Extended Crankshaft is Now Standard on All Model 91 Compressors

Please note effective January 1, 2019, all model 91 compressors (91, F91, D91, FD91, T91, FT91) are shipped with the extended crankshaft. The previous option for the short crankshaft is no longer available so the extended crankshaft comes at no additional charge. The reason for this change is to provide more clearance between the crankcase, flywheel, and belt guard. A longer crankshaft makes it easier to mount the compressor and belt guard to the baseplate.

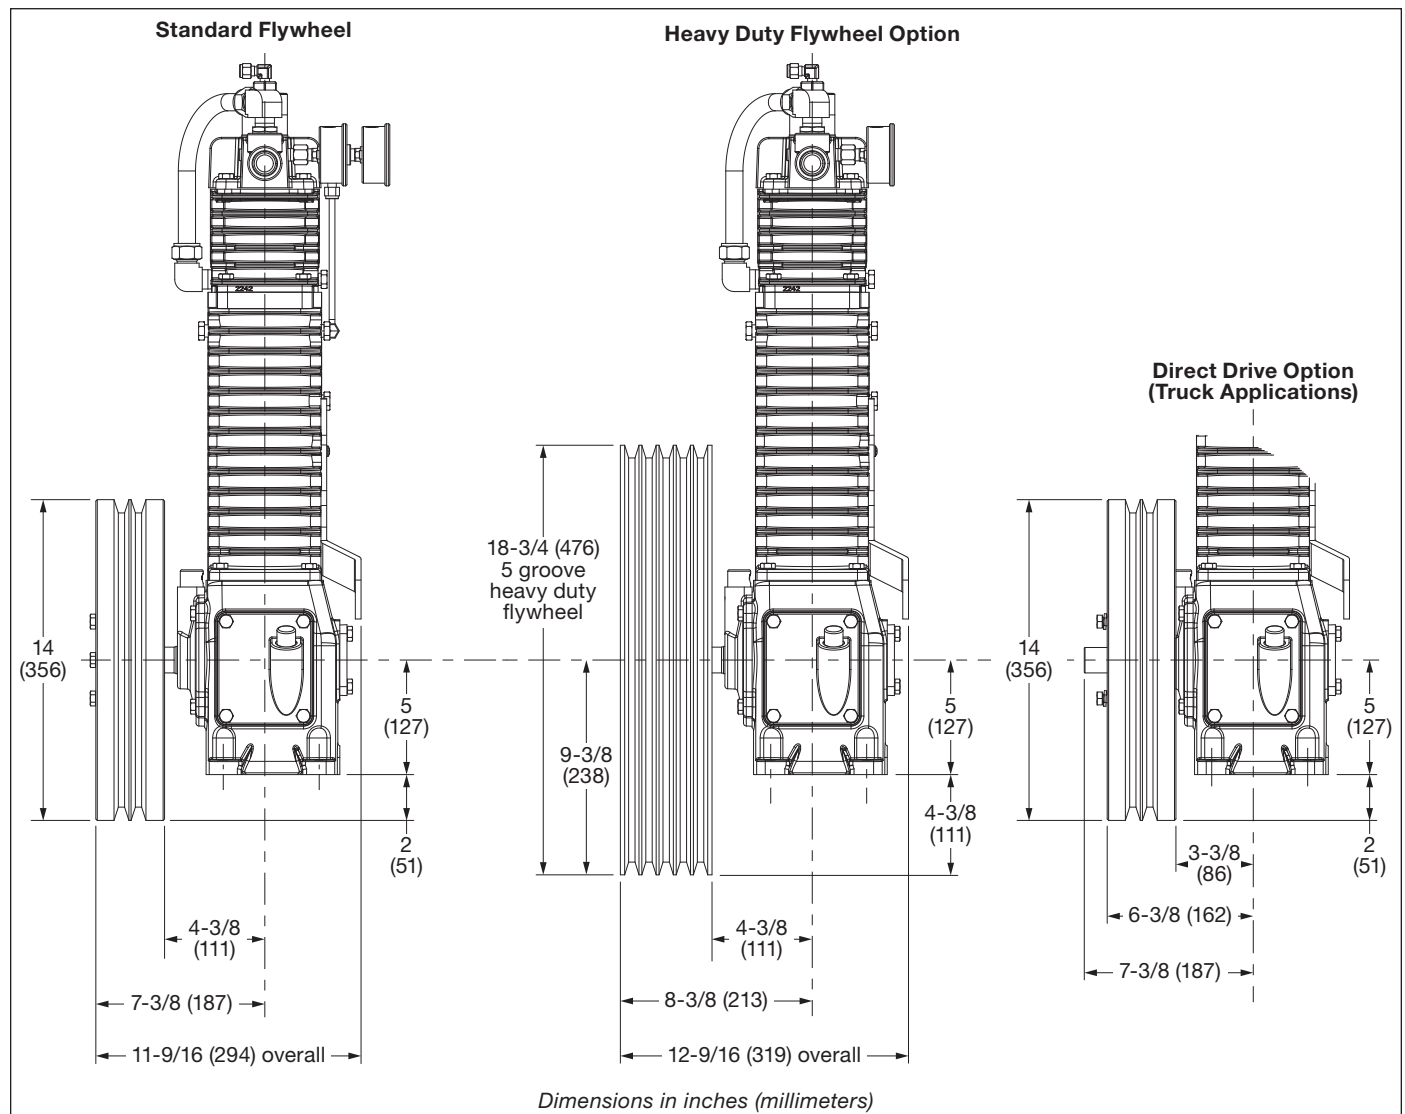
Listed below are the dimensions for a model 91 flywheel using the longer extended crankshaft with three different configurations. NOTE: Bare compressors are shipped with the flywheel in the same position as the direct drive option.

For illustration purposes, a model D91 is shown above but the dimensions apply to all model 91 compressors.
